Subject: Duke Energy Corporation  
Oconee Nuclear Station, Units 1 and 2  
Docket Numbers 50-269, 50-270, and 50-287

Technical Report NFS-1001A, Revision 5,  
January 2001, *Reload Design Methodology*

**DUKE POWER COMPANY  
OCONEE NUCLEAR STATION  
RELOAD DESIGN METHODOLOGY  
Technical Report NFS-1001A**

RESPONSES TO NRC QUESTIONS  
OF  
OCTOBER 16, 1980

Figure 5-i (FSAR Figure 14-9)

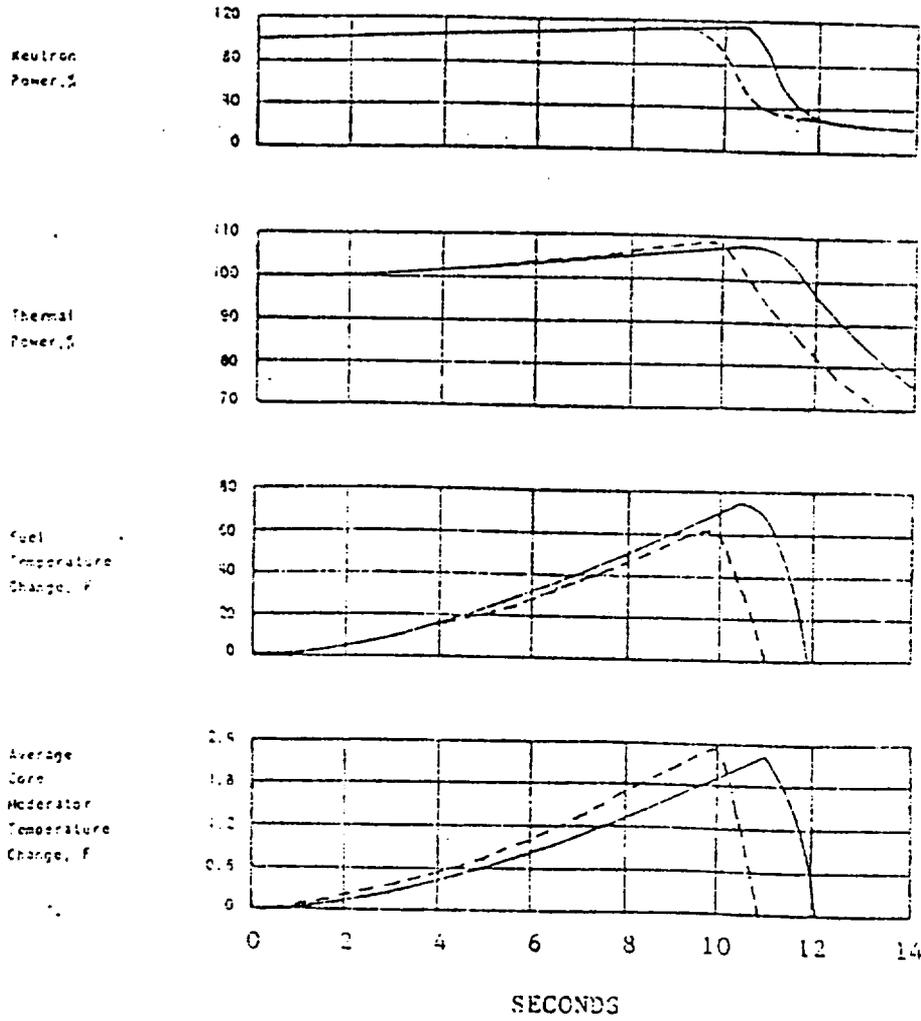
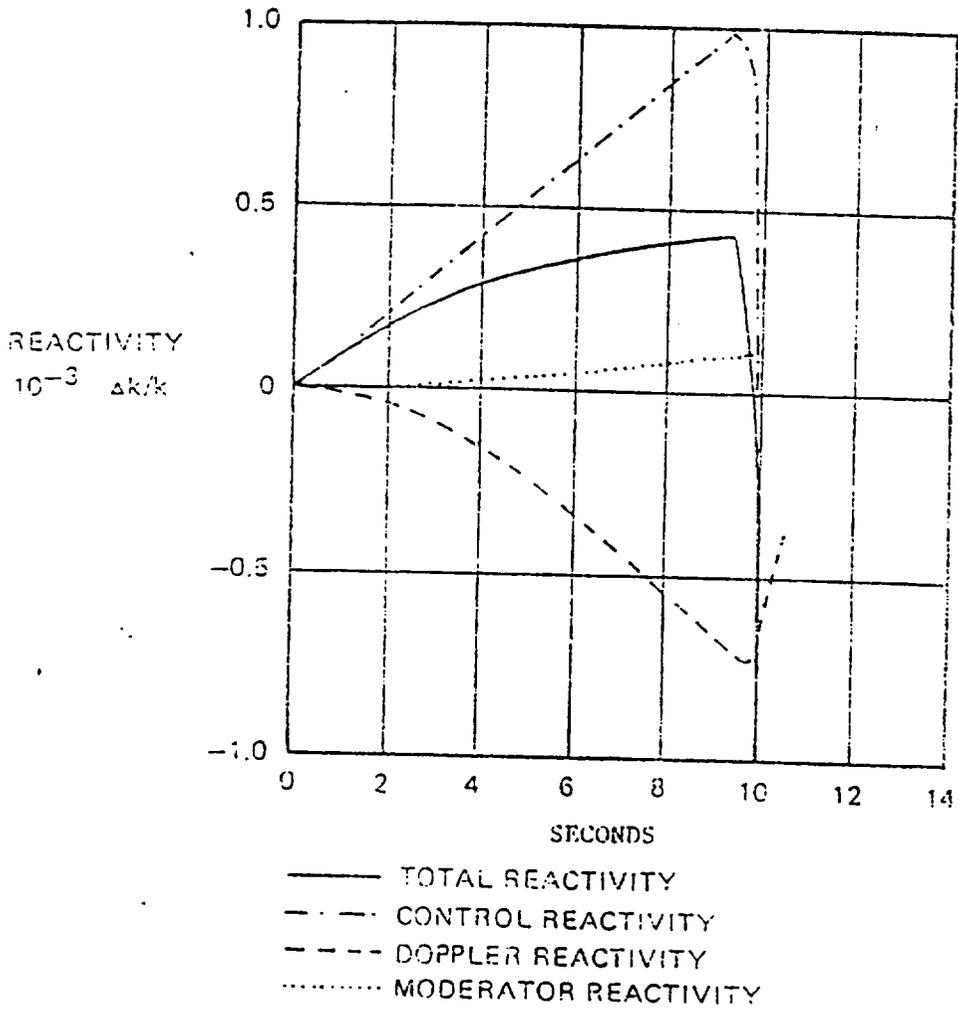
Q. 5. Paragraph 8.3.3. Rod Withdrawal Accident at Rated Power Operation

Give the variation of the reactivity as in 4. above.

A. 5. The reactivity response of the rod withdrawal accident at rated power simulation performed by B&W and used in the original FSAR analysis is not available. In order to respond to the question a similar analysis was performed by Duke Power Company using the RETRAN code and matching as accurately as possible the modeling assumptions of the original analysis. Figure 5-1, a revised FSAR Figure 14-9, shows the comparison between the original analysis (solid lines) and the new analysis (dashed lines). No attempt was made to match the results of the original analysis, the intent being to match the assumptions and initial conditions. The similarity between the results of the two analyses supports the conclusion that the reactivity response of the new analysis shown in Figure 5-2 is representative of the original analysis.
